Determination 2026/006

An authority's decision to issue two notices to fix for building work carried out without a building consent

970 Neudorf Road, Dovedale, RD 2, Upper Moutere

Figure 2: Floor plan diagram showing the dwelling and sleepout. Not to scale.

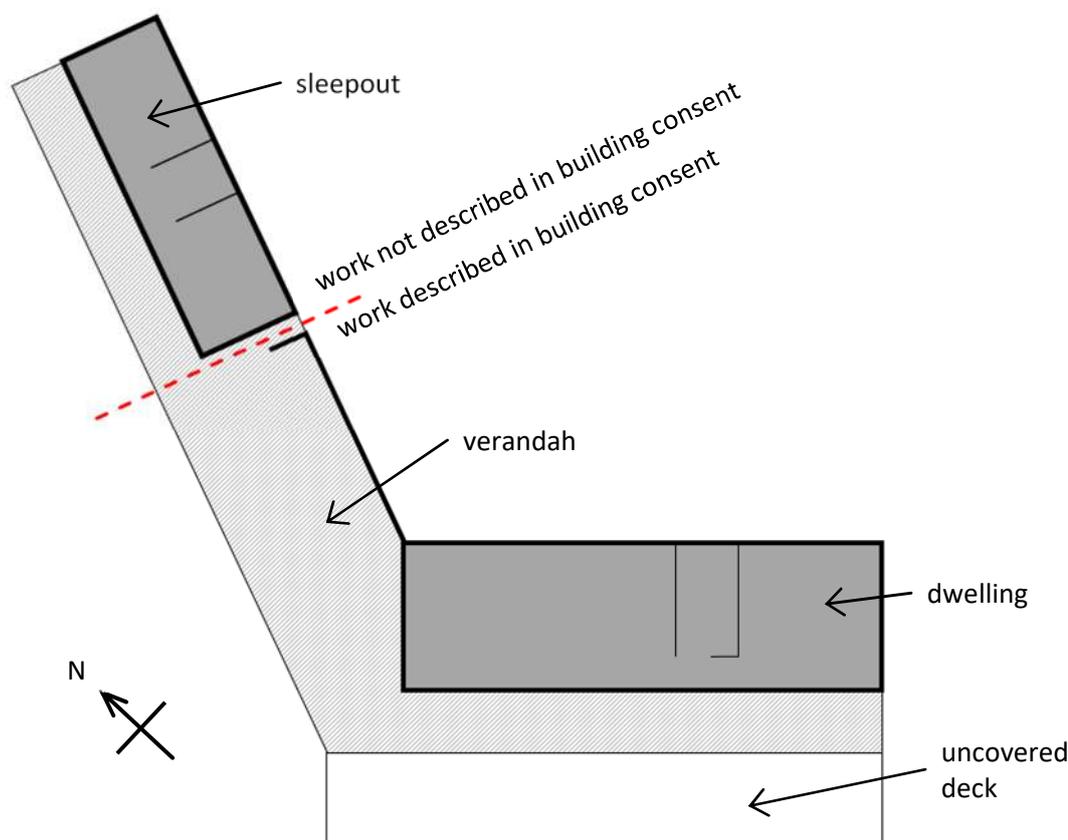
- 2.4. The sleepout is located adjacent and to the north of the dwelling subject of the building consent (see Figures 1 and 2). The sleepout is timber-framed, with a combination of steel and timber framed subfloor and timber pile foundations.
- 2.5. The owners state, along with notations on the architectural plans, that the area of the sleepout is 30m², with a 18m² veranda.⁶ I have not been provided with any observed measurements of the sleepout from the parties.
- 2.6. The veranda of the sleepout was later extended (in or around March 2024) to 20.9m², when it was connected to the dwelling's verandah.

There is a building being constructed next to the consented work. The owner advises me this is a sleepout under 30 square meters being constructed under schedule 1 of [the Act]. It is constructed within 1 meter of the consented building there by not meeting requirements of building code clause C – protection from fire.

Please have designer submit fire rated construction details or alternative solution as a formal amendment to this consent.

- 4.9. Despite the requirements of clause 3A(1), at the time, subclause (2)¹² stated "However, subclause (1) does not include building work in connection with a building that is closer than the measure of its own height to any residential building or to any legal boundary". The authority's inspections state the sleepout is 'constructed within 1 metre of the consented building' and in their correspondence

of 21 March 2025 state the sleepout 'fails to comply' with clause 3A(2) for this reason. The owner's acknowledge the distance between the sleep out and the consented dwelling with attached veranda but consider the relevant consideration is the distance between the sleepout and the dwelling's habitable rooms (which is some 8 metres). With respect I disagree with this interpretation; clause 3A(2) is clear in its reference to "a building that is closer... to any residential building" and does not refer to specific *parts* of a residential building. The sleepout is more than 1m high and within 1m of the consented dwelling, so is 'is closer than the measure of its own height to any residential building' and accordingly, does not meet the criteria of clause 3A(2).

- 4.12. Therefore, the exemption in clause 3A and 3B do not apply given the distance of the sleepout to the consented residential dwelling and accordingly required building consent.
